Re: On-Going Services
Heritage Park Section 3 Subdivision Final Plat and Construction Plans – 1st Submittal Review
Angleton, Texas
HDR Job No. 10336228

HDR Engineering, Inc. (HDR) has reviewed the plat for the above referenced subdivision and offers the following comments:

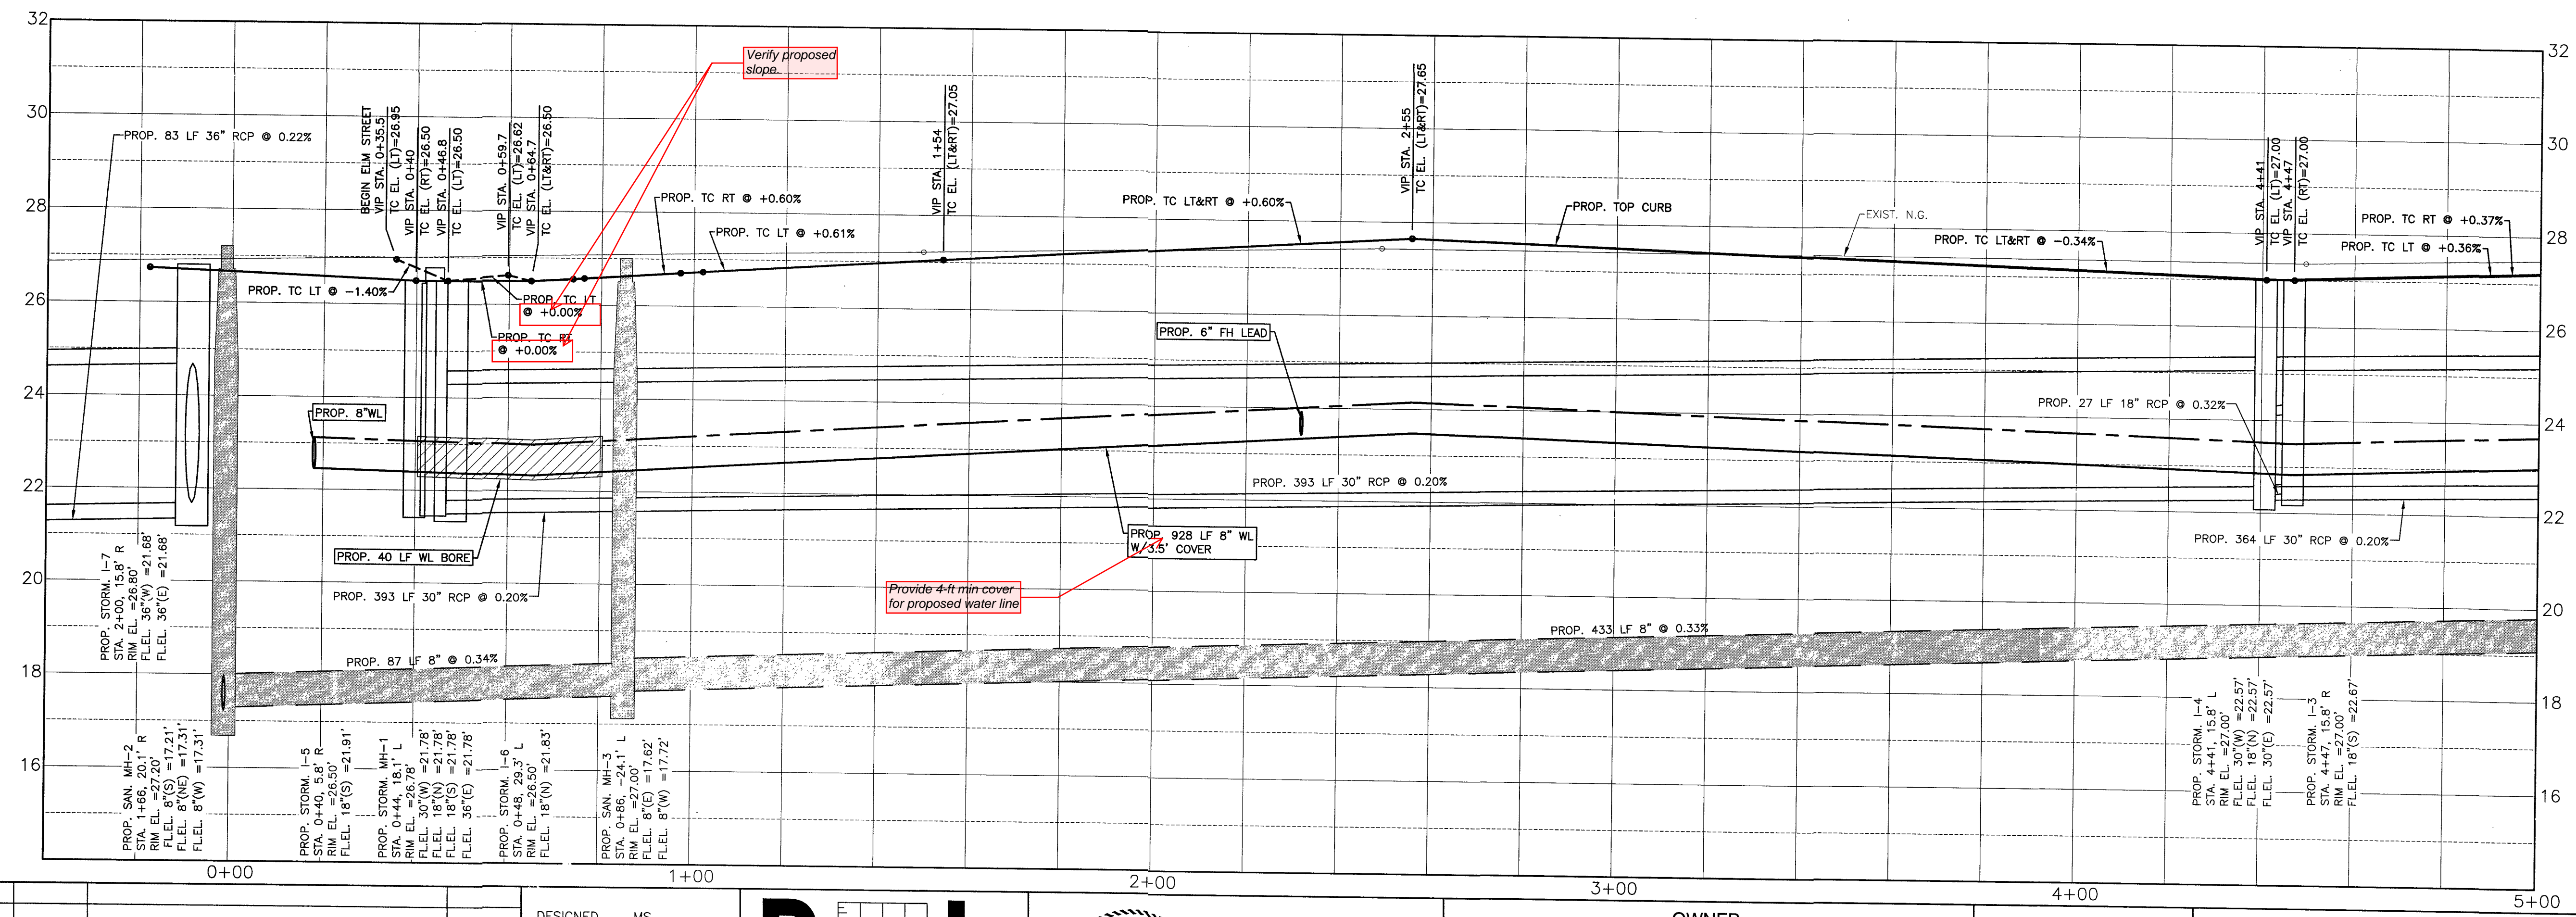
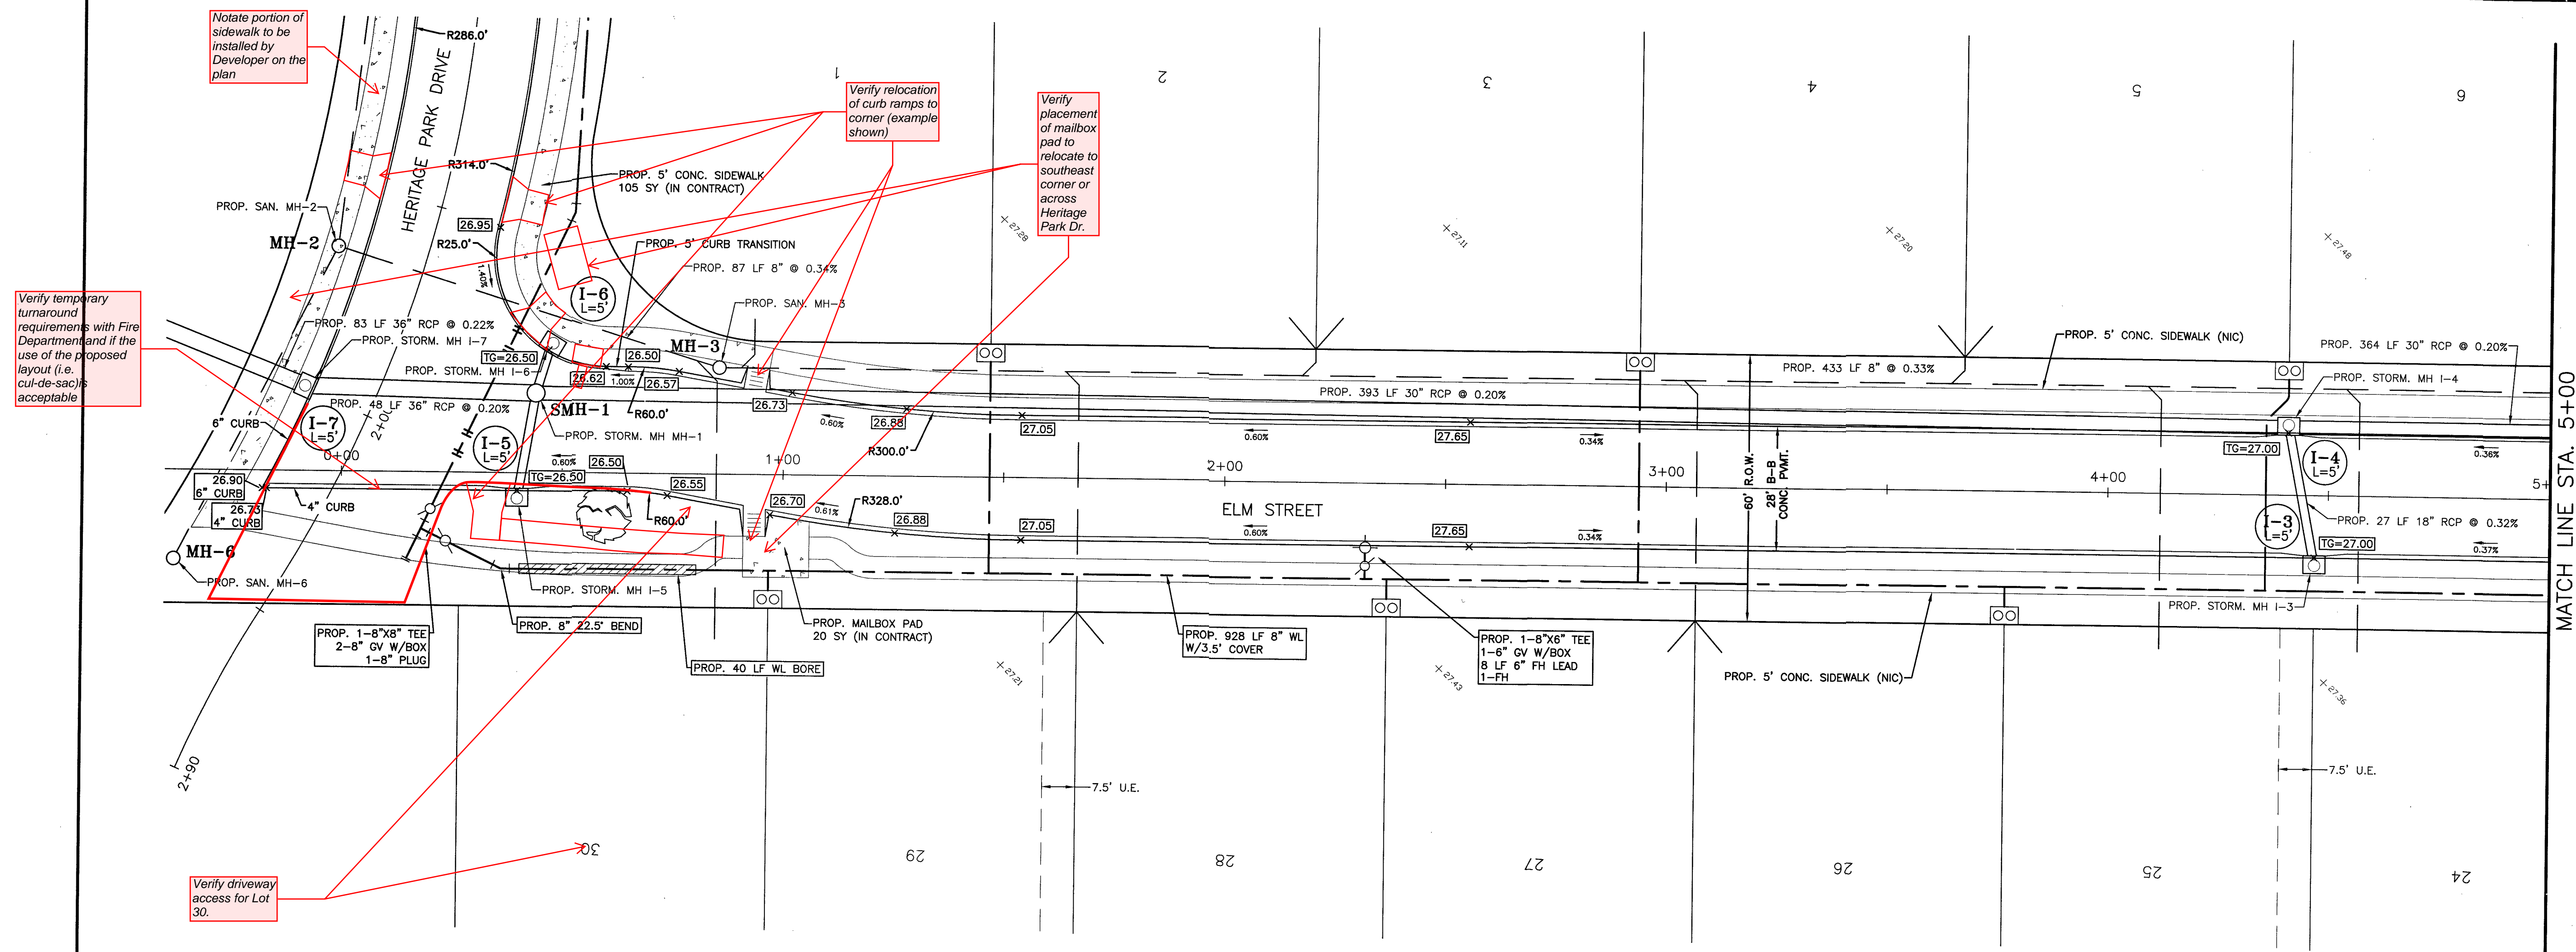
1. Notate proposed tie-in and to verify manhole condition. Coordination shall be made with Public Works prior to tie-in for any necessary operation of the lift station.
2. Provide 4-ft minimum cover for proposed water line.

PLAN & PROFILE
ELM STREET
 PROJECT NO. 15012

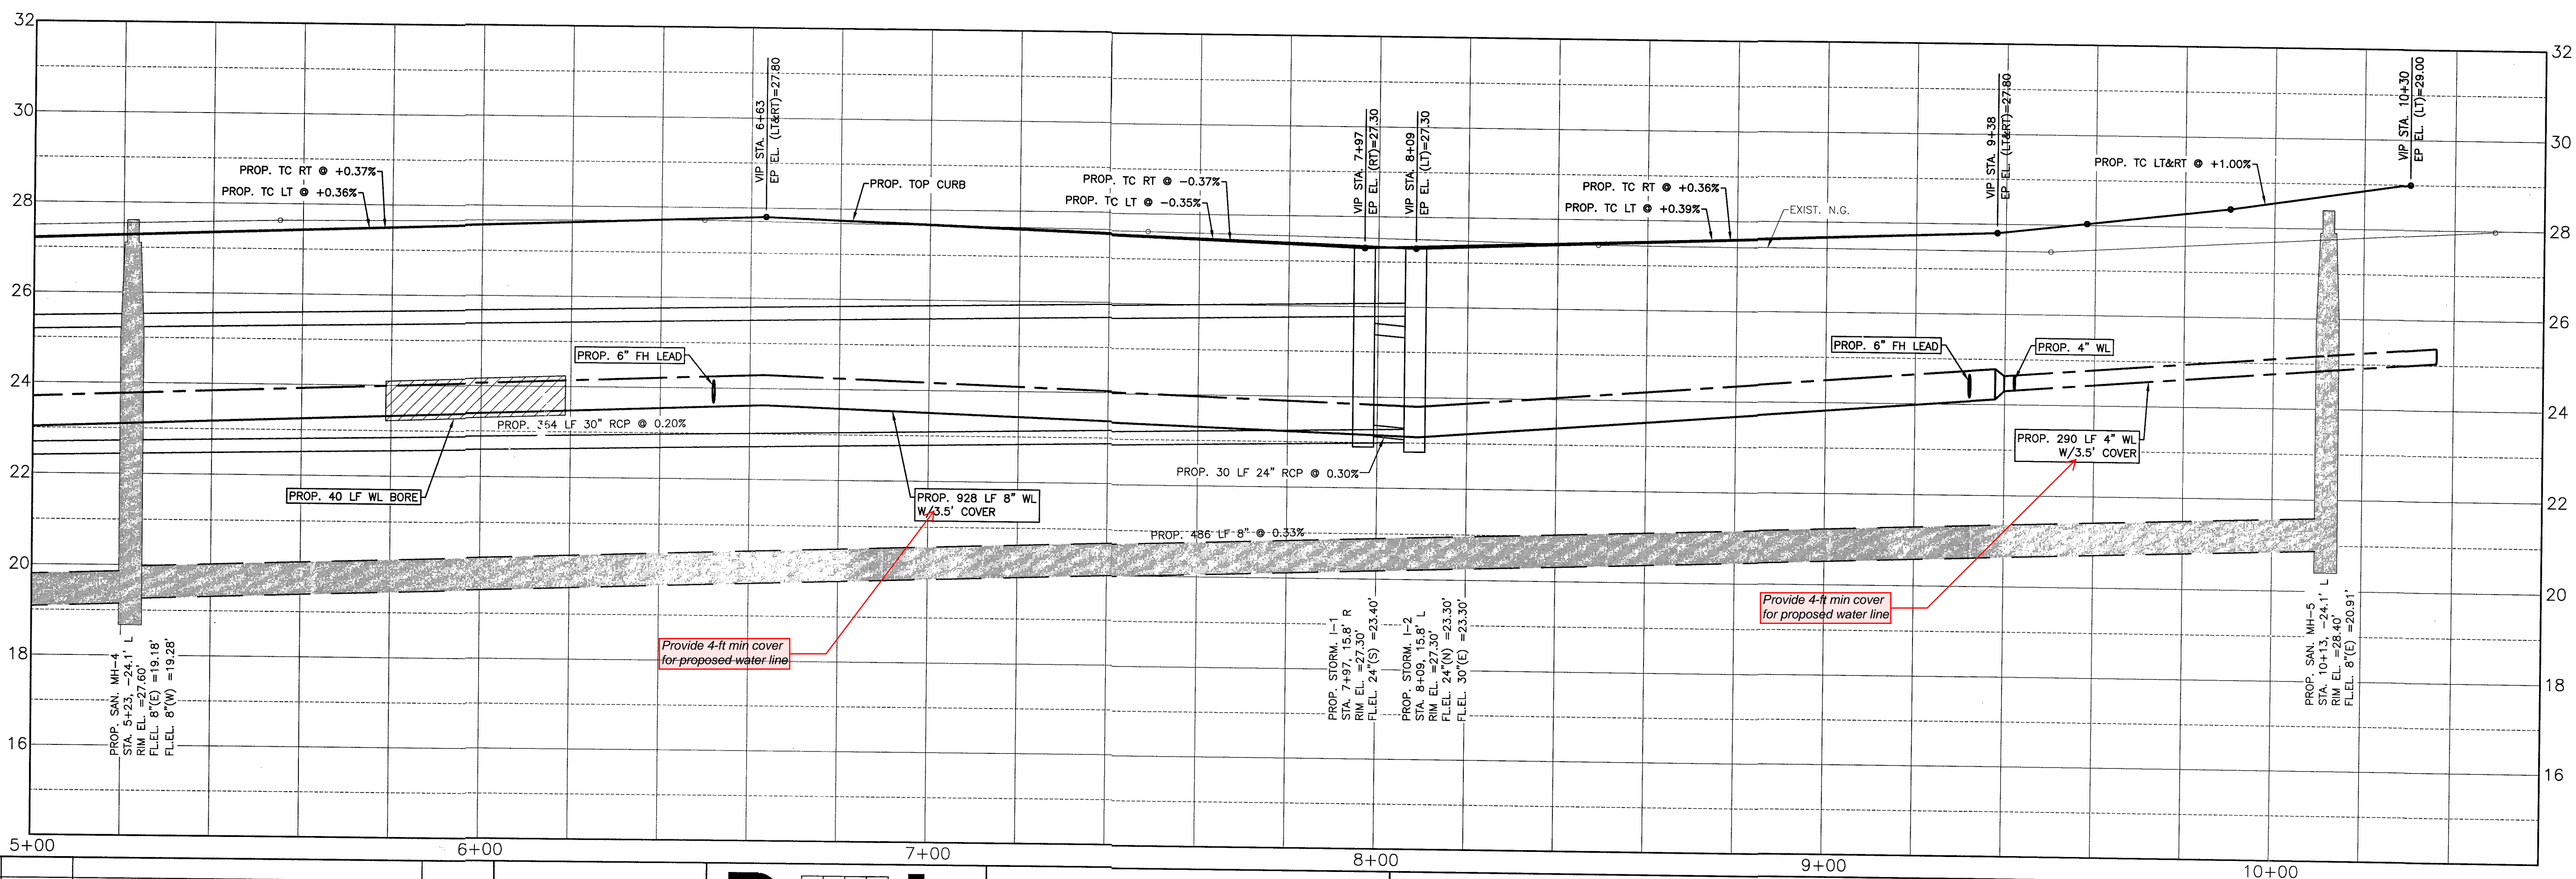
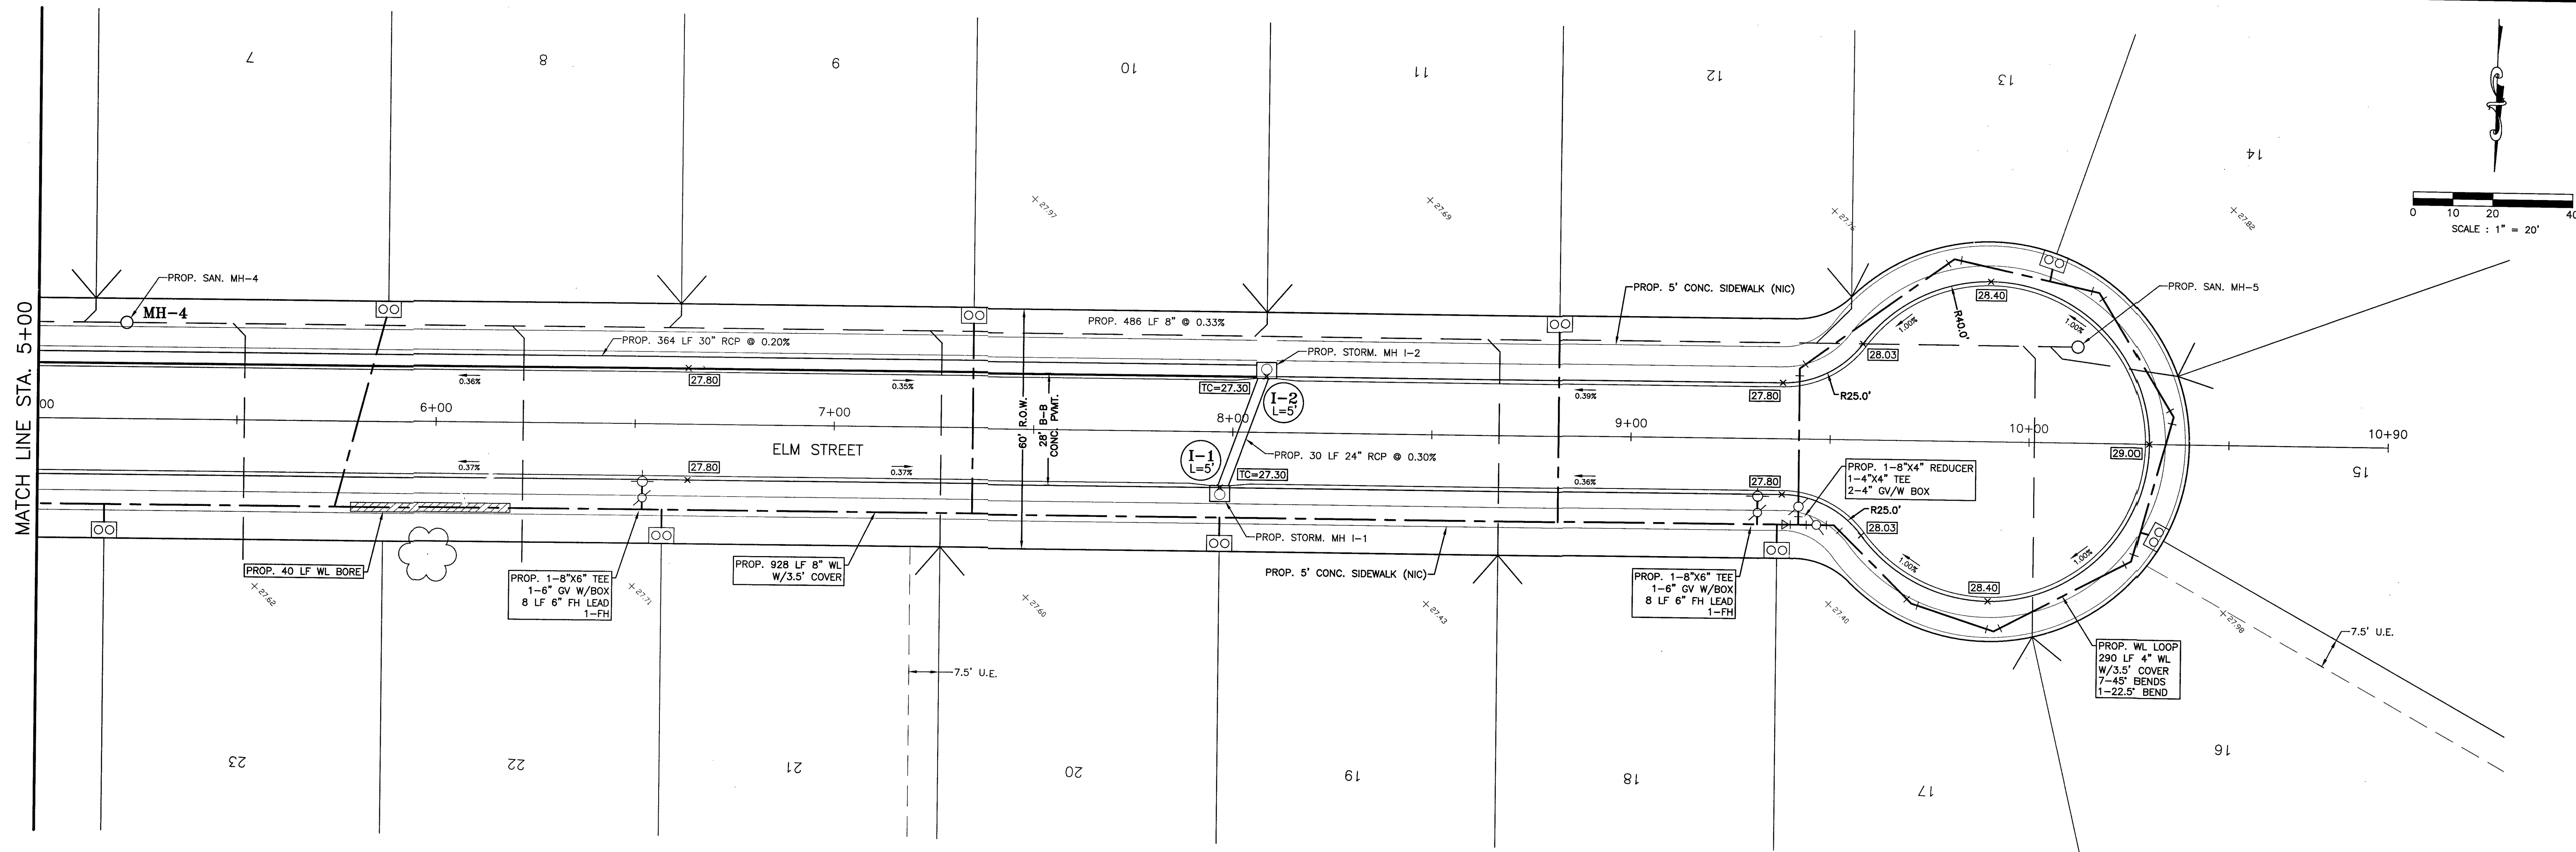
1. Notate portion of sidewalk to be installed by Developer on the plan.
2. Proposed layout for Heritage Park Drive is not per preliminary plat information submitted. Verify design for end of street and verify temporary turnaround requirements with Fire Department for end of Heritage Park Drive.
3. Verify relocation of curb ramps to corners (example shown on plans).
4. Verify placement of mailbox pad to relocate to southeast corner or across Heritage Park Dr.
5. Verify driveway access for Lot 30. Existing tree, proposed curb ramp, and proposed inlet appear to obstruct placement.
6. Verify proposed slope (proposed 0.00%) at intersection and update plans.
7. Provide 4-ft minimum cover for proposed water line.
